Docket Number:	25-IEPR-03
Project Title:	Electricity and Gas Demand Forecast
TN #:	268080
Document Title:	COMMENTS ON THE DECEMBER 17, 2025, IEPR COMMISSIONER WS ON ENERGY DEMAND FORECAST RESULTS
Description:	CALCCA'S COMMENTS ON THE DECEMBER 17, 2025, IEPR COMMISSIONER WS ON ENERGY DEMAND FORECAST RESULTS
Filer:	Shawn-Dai Linderman
Organization:	CALIFORNIA COMMUNITY CHOICE ASSOCIATION
Submitter Role:	Intervenor
Submission Date:	12/30/2025 4:53:01 PM
Docketed Date:	12/30/2025

DOCKET NO. 25-IEPR-03

**CALIFORNIA COMMUNITY CHOICE ASSOCIATION'S COMMENTS
ON THE DECEMBER 17, 2025, IEPR COMMISSIONER WORKSHOP ON
ENERGY DEMAND FORECAST RESULTS**

Figure 1. DAWG WG Meeting Presentation on Known Loads
October 30, 2025⁸

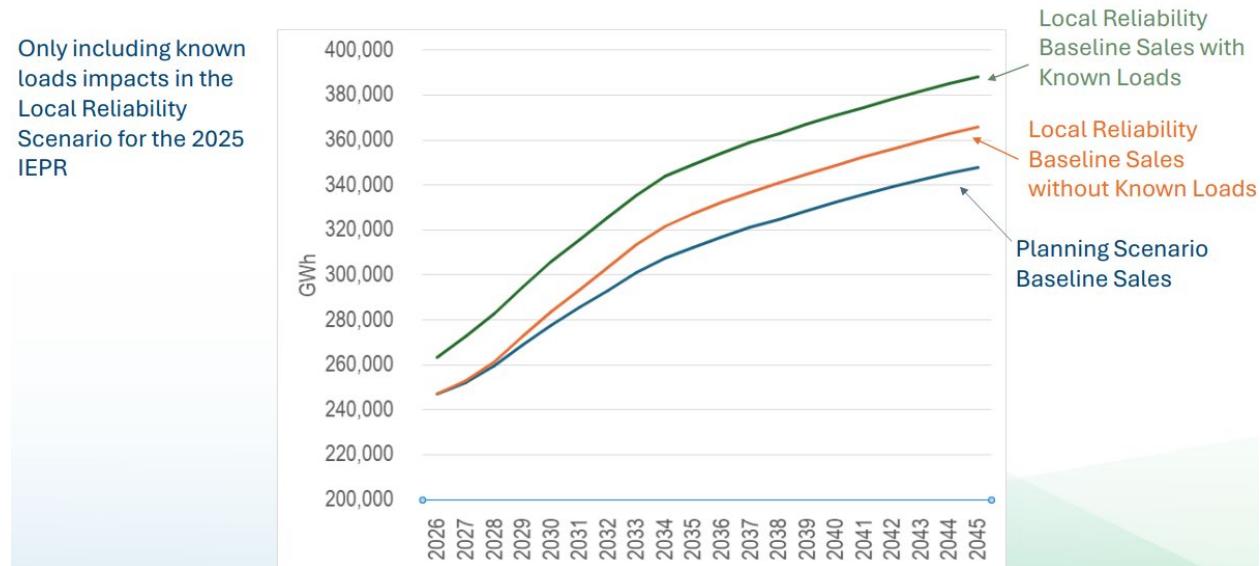
Forecast Results (IEPR Results WS).⁷ Instead, Known Loads would be incorporated in only the Local Reliability Forecast, as reflected in Figure 1, below.

At the Workshop, the treatment of Known Loads within the Planning Forecast was changed to “TBD.”⁹ Based on CalCCA’s conversations with Commission Staff, this “to be determined” label reflects a reconsideration of whether the Known Loads should be added to the Planning Forecast.

Incorporating Known Loads is not necessary for the Planning Forecast given its intended purpose. In fact, the Commission’s incorporation of Known Loads into the Planning Forecast would reflect a variation from recent practices. As Figure 2 below shows, there is no evidence that recent IEPR Planning Forecasts of peak demand have inherently erred on one side or the

Figure 2.
IEPR Planning Forecasts Compared to Recent 1-in-2 Peak Demand

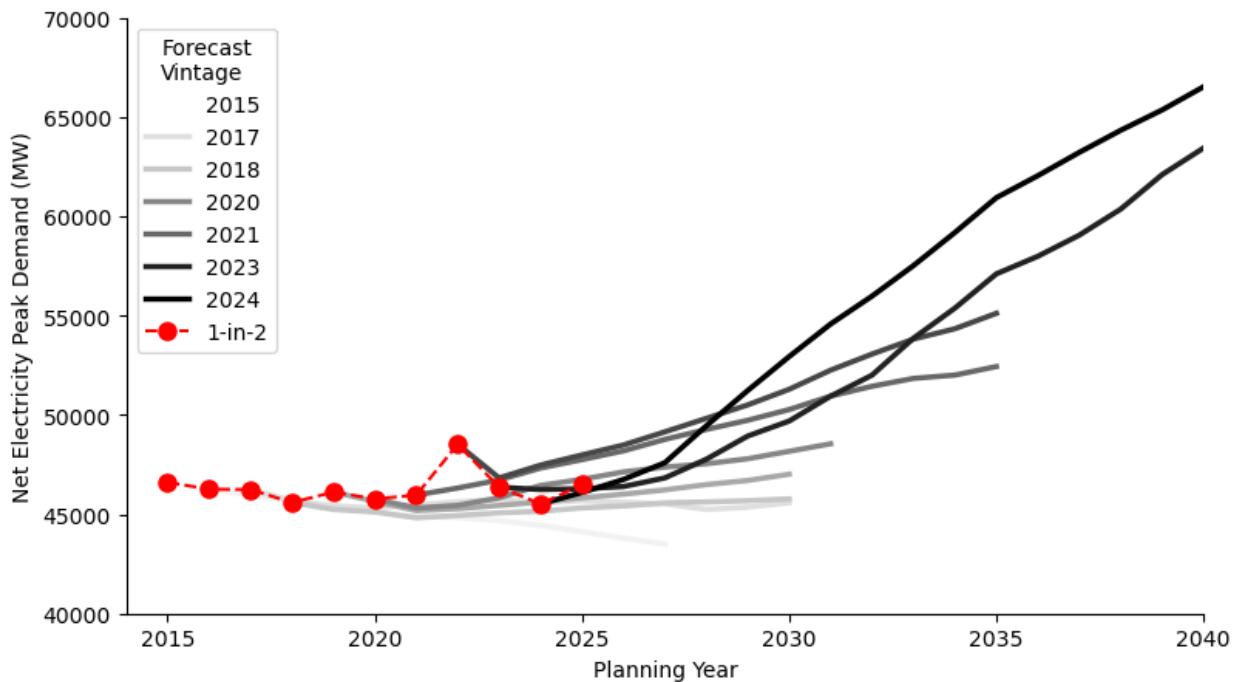
other, at least in the near term. The case for a new methodology that systematically increases load forecasts has not been thoroughly vetted, given its potentially significant impact on affordability. In fact, if past methodologies have been reasonable, the new Known Loads methodology may introduce errors and over forecasting. CalCCA understands that the initial point for each forecast reflects the Commission's estimate of weather-normalized peak load. This trend suggests a wholesale overhaul in the forecast inputs (i.e., incorporating Known Loads into the Planning Forecast) is unnecessary.

Figure 3.
Shift in EV adoption forecasts between 2024 and 2025 is consistent with alternative EV forecasts

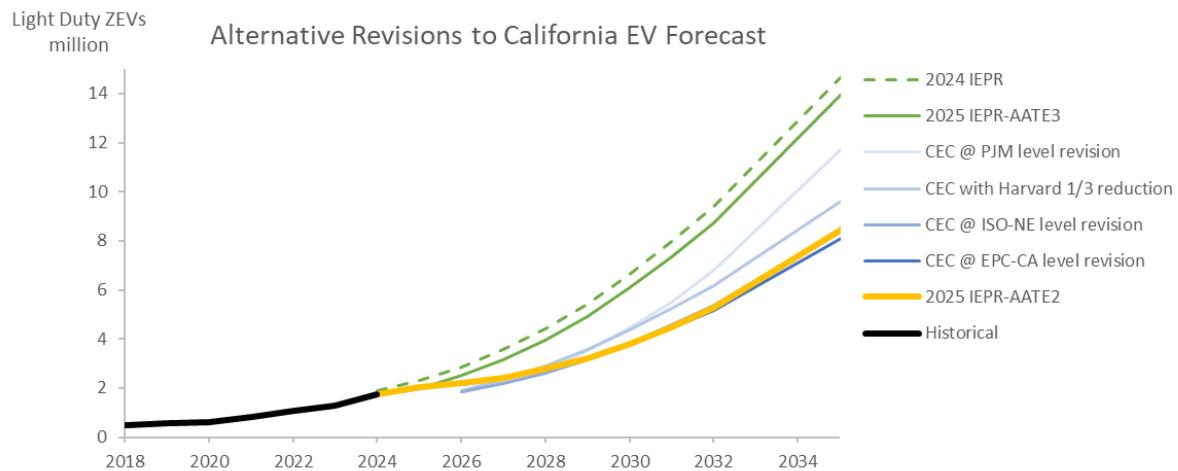
The comparison to other forecasts demonstrates the reasonableness of the Commission's approach. For example, the Commission at PJM level revision line represents the expected EV forecast if the change from the IEPR 2024 to IERP 2025 EV forecast were to be proportional to the revision in the PJM Interconnection's revision between the PJM 2024 and PJM 2025 vintage. The amount of EVs in the 2025 IEPR forecast with AATE Scenario 2 is much more aligned with the alternative forecasts than the AATE Scenario 3. CalCCA encourages the Commission to revisit the EV forecast in the 2026 IEPR demand forecast, as additional EV sales data from the fourth quarter of 2025 and early 2026 can inform the response of customers and companies to the shifts in federal policy support for electric vehicles.
